## BX PRV Station & Watermain Upgrade Reference No. 2016-E372.12.2

May 10, 2017

### ADDENDUM NO. 1

The following list contains questions received to this RFP process and their corresponding answers.

TYPICAL TRENCH  
DETAIL  
N.T.S

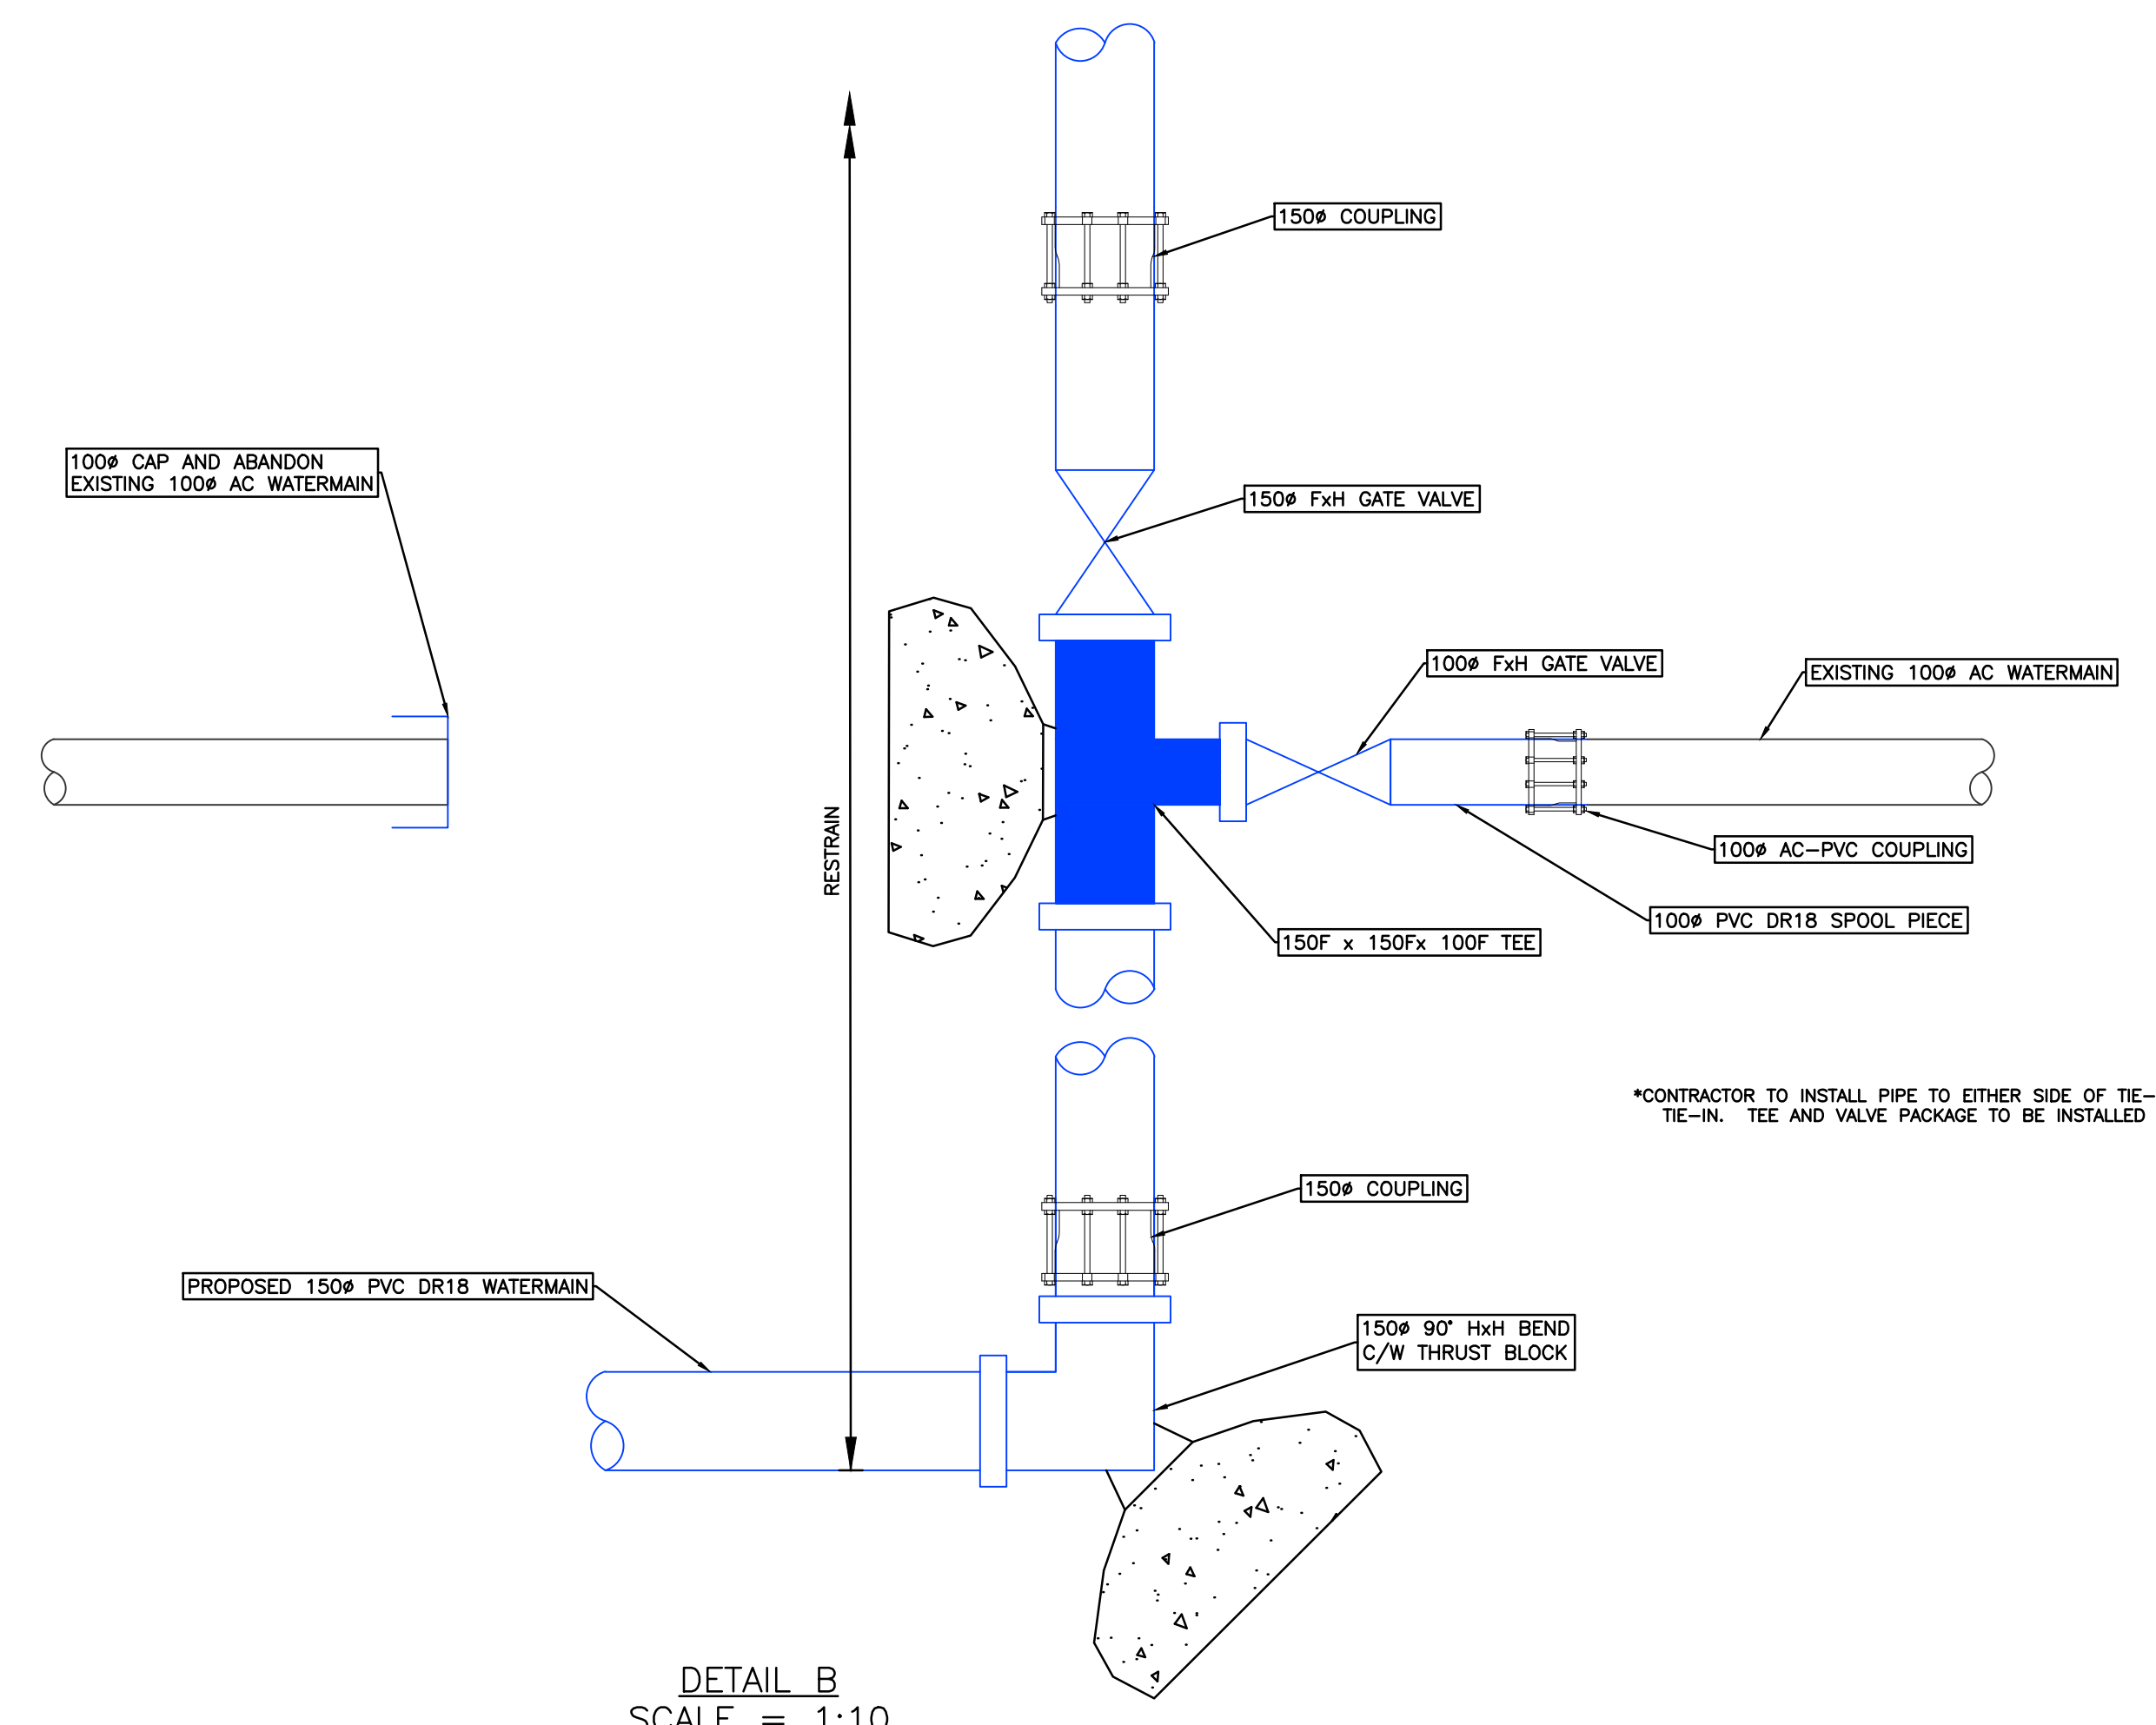
Q1	Is there currently a scheduled site meeting for this opportunity?
A1	<i>There will be a non-mandatory site meeting on <b>Tuesday, May 16<sup>th</sup> at 9AM</b>. The meeting will commence at the PRV site.</i>
Q2	M-01 shows inside dimensions of PRV chamber 4100L X 2000W X 2100H while M-02/03 identify inside dimensions of 4500L X 2000W X 2100H. Which dimensions are correct?
A2	<i>The correct dimensions are 4100L X 2000W X 2100H. Revised drawings are attached.</i>
Q3	Are granular base and granular sub-base, in relation to asphalt restoration, to be paid under SOQ or are they incidental to asphalt restoration?
A3	<i>Asphalt restoration will include restoration of the asphalt above the trench (base/subbase is included in the trench unit rate) as well as a grind and overlay 35 mm of asphalt as per MMCD G5 throughout the rest of the area shown for paving.</i>
Q4	What is the road structure for Silver Star RD and Dedecker RD?

A4	<i>See trench detail included in Addendum 1 drawings.</i>
Q5	For items 15 – 17, what material should be used for imported backfill material?
A5	<i>See trench detail included in Addendum 1 drawings.</i>
Q6	For items 15 – 17, will excavated material from trenching be paid under item 9 (common excavation) or will the excavation and disposal of excavated material be considered incidental to installation of water mains.
A6	<i>Excavation and disposal is part of the watermain as per MMCD. The common ex is only for the PRV site.</i>
Q7	Will lot/driveway restoration be paid under SOQ or will this activity be incidental to water main and servicing installation?
A7	<i>If the restoration driveway is paved, restoration will be under the permanent pavement restoration item. If it is gravel, restoration will be under the watermain unit price.</i>
Q8	Section 2.3 of Piping Systems “.1 All non-threaded piping shall be fabricated from Schedule 40, 316L stainless steel pipe.” The notes on Drawing M-01 Specify Sch.40 304 Stainless Steel, please clarify which is required.
